Safety Recall 23KWK: C500/T660/T800/W900 Seatbelt Intermediate Connecting Point (ICP) Bar Spacer

23KWK / 23V717 / 2023-573

Safety Recall: C500/T660/T800/W900 Seatbelt Intermediate Connecting Point (ICP) Bar Spacer

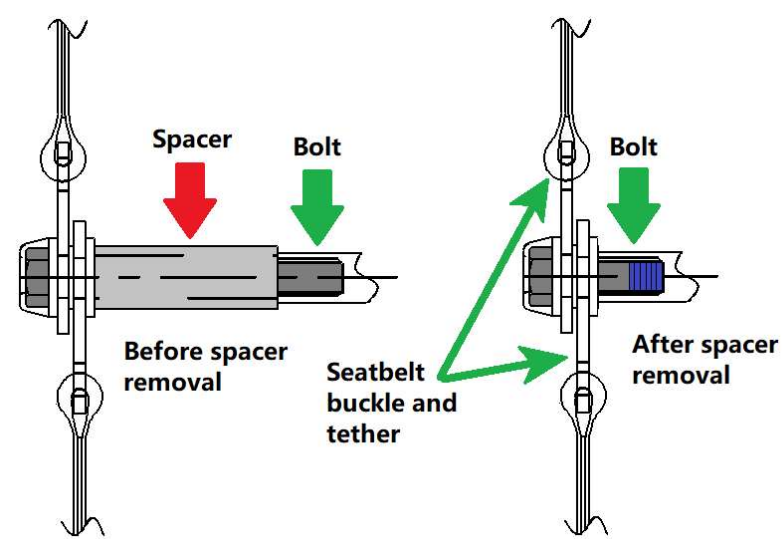
1. Remove and discard the bolt securing the seatbelt buckle to the ICP bar on the right side of the seat.
2. Remove and discard the spacer.

3. Apply blue Loctite 242 or equivalent to the new bolt threads.
4. Install the new seatbelt buckle bolt to the ICP bar. Torque to 45 Lb-Ft. Re-install washers as removed to ensure buckle and tether hardware is

correctly aligned (washer style/alignment may vary by vehicle).
